SITE PLAN REVIEW

LOT NO. 28 REGISTERED PLAN 43M-2013

LOT GRADING PLAN
55 DEGREY DRIVE

GREENYORK HOMES
DEGREY DRIVE,
CITY OF BRAMPTON

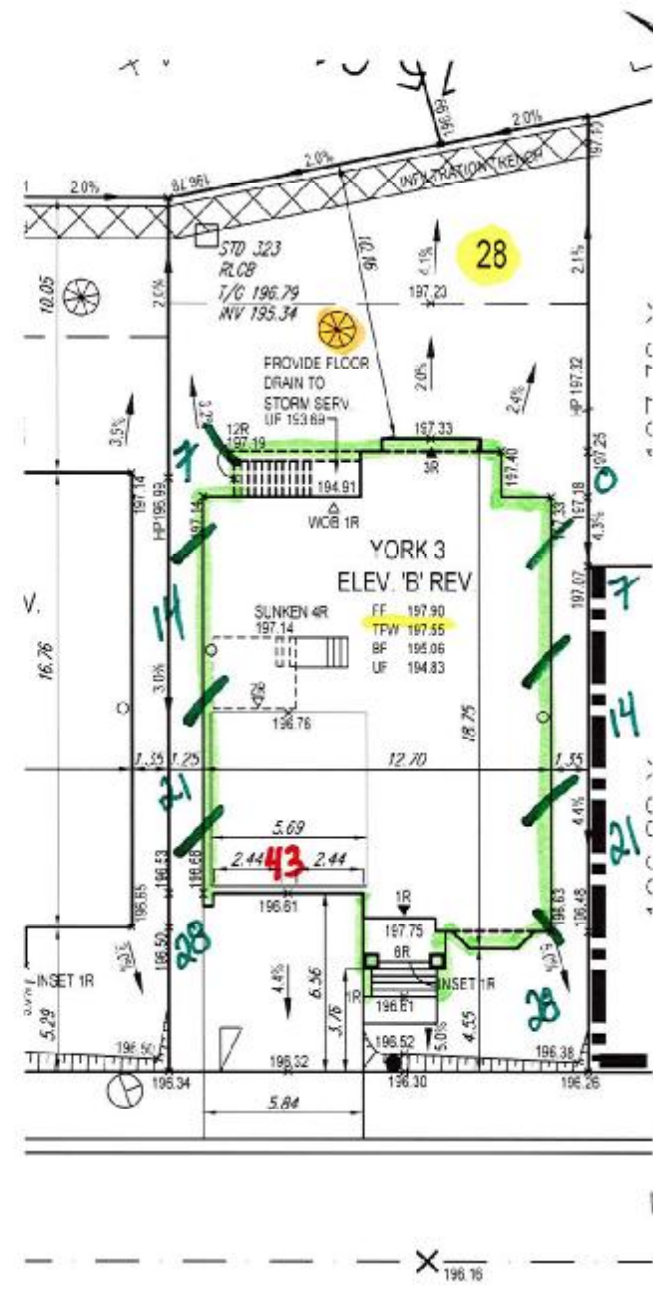
SAN INV = 193.59 ✓ 1.29
STM INV = 193.79 ✓ 1.04

PROVIDE POURED IN PLACE CONC. STEPS
ALL STEPS SHALL BE POURED IN-PLACE
W/ MASONRY VENEER ON THE SIDES
